Errata Sheet

Product Family: DL405

Manual Number D4-USER-M

Revision and Date 4th Edition, August 2009

Accumulator Timer Example Using Comparative Contacts

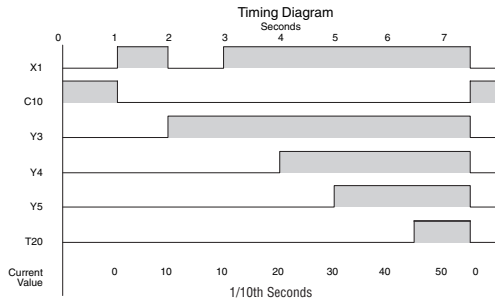
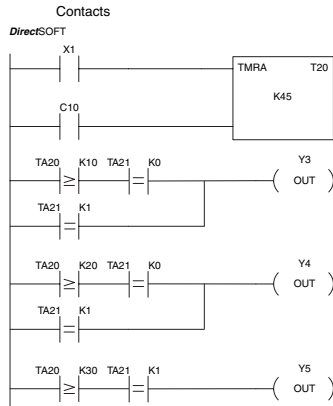
Page 5-45. Accumulating Timer (TMRA) and Accumulating Fast Timer (TMRAF); Accumulating Timer Example Using Comparative Contacts

Replace this entire subsection with the following:

In the following example, a two-input timer is used with a preset of 4.5 seconds. Comparative contacts are used to energized Y3, Y4, and Y5 at one second intervals respectively. The comparative contacts will turn off when the timer is reset.

Page 5-80. Exclusive OR Formatted (XORF) Example

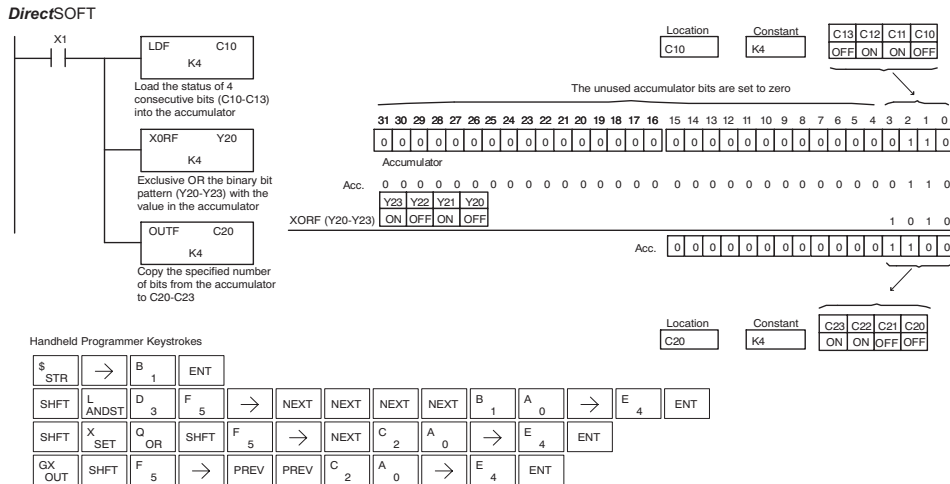
Replace the example at the bottom of the page with this one (some of the values were changed):
